**DEPARTMENT OF TRANSPORTATION
STATE OF GEORGIA**

SUBJECT PROJECT CONCEPT REPORT APPROVAL

**HPP-0000-00 (248), FULTON
GDOT P.I. NO. 0000248
FULTON CO # T104
ROSWELL RD (SR 9) @ DUNWOODY PLACE
INTERSECTION IMPROVEMENT PROJECT**

INTERSECTION IMPROVEMENT PROJECT
ROSWELL RD (SR9) @ DUNWOODY PLACE

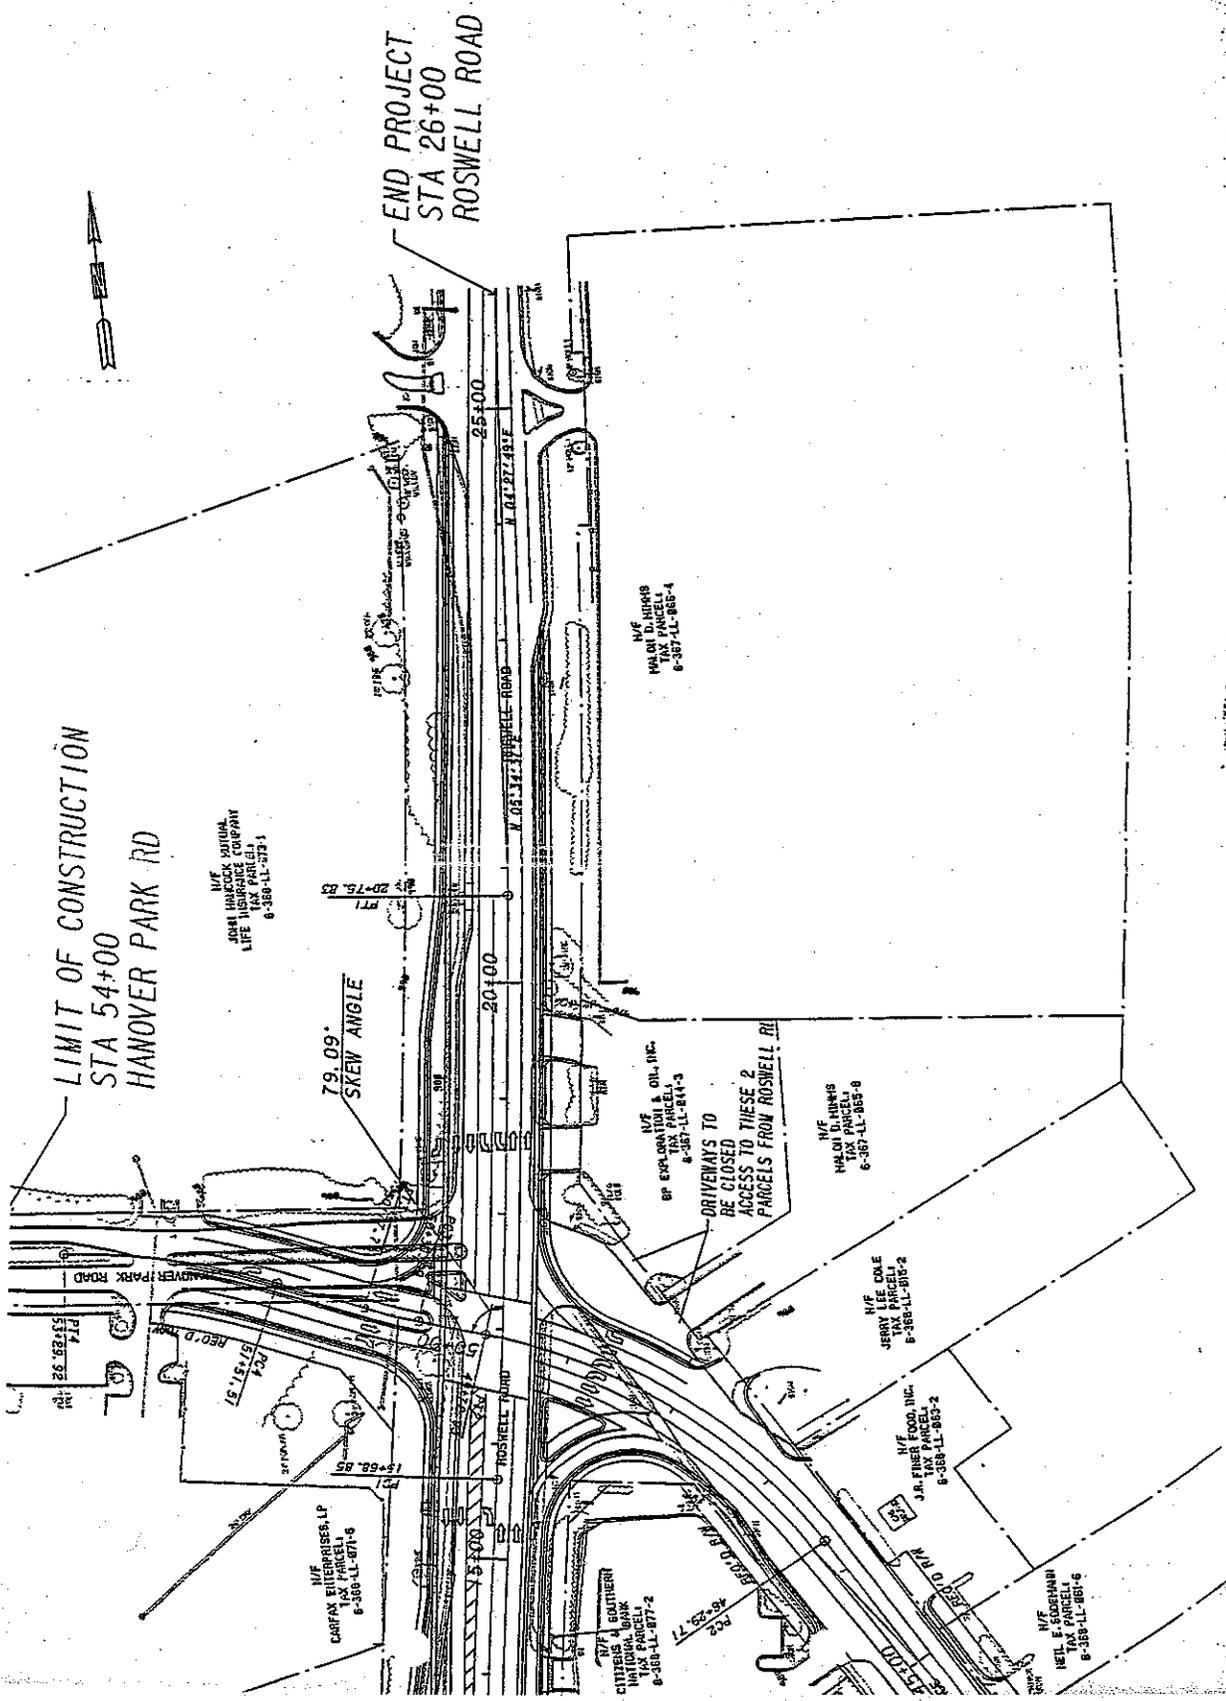
- Suggested 12' lanes across the road and include 4' bike lanes (**DONE SEE CONCEPT LAYOUT**)
- Mentioned project funding was \$400,000 (**PROJECT IS FULLY FUNDED**)
- Roswell will have 24' to accept when we widen to 2-12' lanes plus bike lanes (**OK**)

- Suggested 11' lanes across the road, later agreed with Darrell for 12' lanes (**OK SEE ABOVE**)
- Question access for Parcel next to BP from Dunwoody (**SEE CONCEPT LAYOUT**)
